**EXPERT-PANEL REVIEW
OF CNWRA VOLCANISM RESEARCH PROGRAMS**

**Nuclear Regulatory Commission
Contract NRC-02-93-005**

**Center for Nuclear Waste Regulatory Analyses
San Antonio, Texas**

January 1995

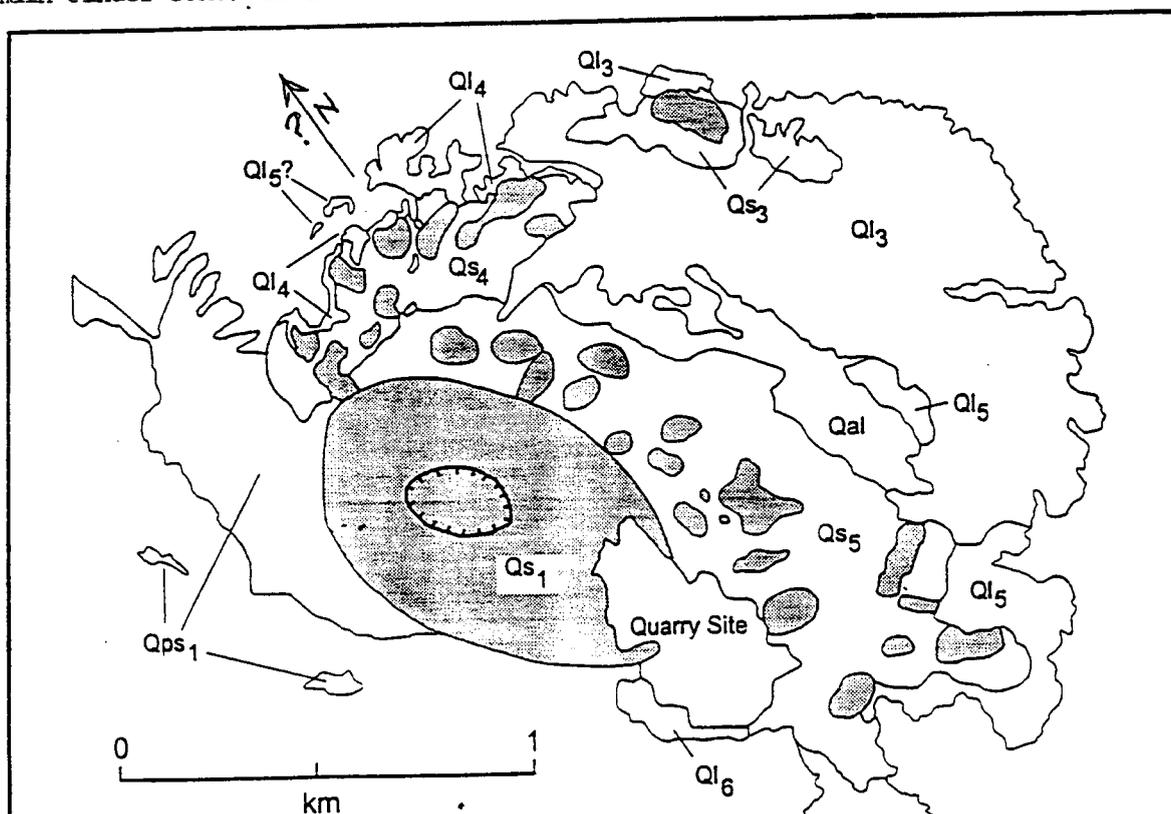
According to some published accounts, Lathrop Wells volcano is "polycyclic" (i.e. polygenetic: built by two or more eruptions). This conclusion appears to depend on the interpretation of scoria mounds found around the foot of the main cone as small cones situated at multiple primary vents. According to this interpretation, rough alignments of these mounds would reflect primary eruptive fissures, three of which (in addition to the fissure presumed to underlie the main cone) would then be required to account for all of the mounds. Also, cinder cone and lava flows have been interpreted to form during separate eruptions.

This published map of Lathrop Wells volcano shows numerous small stippled areas representing small scoria mounds outside of the main cone. I have seen an interpretation in which these mounds mark multiple vents developed on several fissures additional to the main vent. A much simpler interpretation is that the mounds are scoria rafts carried laterally on lava flows. I have watched such rafts forming. Ashy material at one of the small areas labelled Qps is interpreted as pyroclastic surge deposits. I was unimpressed by this interpretation.
